Sea Pro[®] 6 & Sea Pro 7 Retro Fit Kits Now Available

KITS NOW
AVAILABLE
TO ORDER!

Sea Pro 7 (3979820 S)*

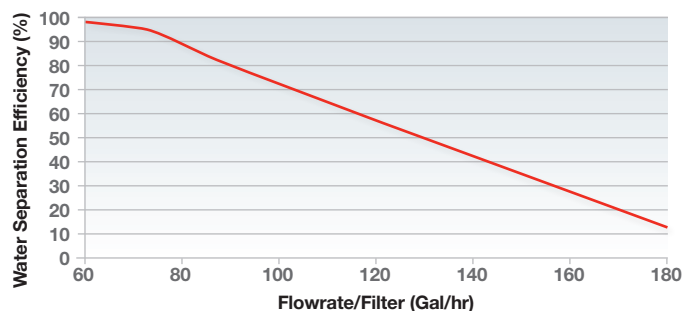
In response to the recent American Bureau of Shipping (ABS) rule change to International Marine Organization (IMO) Resolution A753(18), Cummins Filtration has released retro fit kits for the Sea Pro 6 and Sea Pro 7. To be compliant with the new fire requirement, the retro fit kit must be installed on current Sea Pro 6 and Sea Pro 7* units:

- Seal, Bottom Plate
- Stud Adapter
- Sea Pro 5 Bottom Plate
- 1/4"-20 x 3/4" Cap Screw (6) 3946704 S
- 3/8" NPFT Plug
- Sea Pro 5 Single, label
- Sea Pro 5 Dual/Duplex, label
- Sea Pro 5 Triple/Triplex, label

* **Note: For Sea Pro 7 purchase corresponding filters separately:**

If your unit has a plastic WIF sensor you will need to replace it with our stainless steel WIF (Part 396082600).
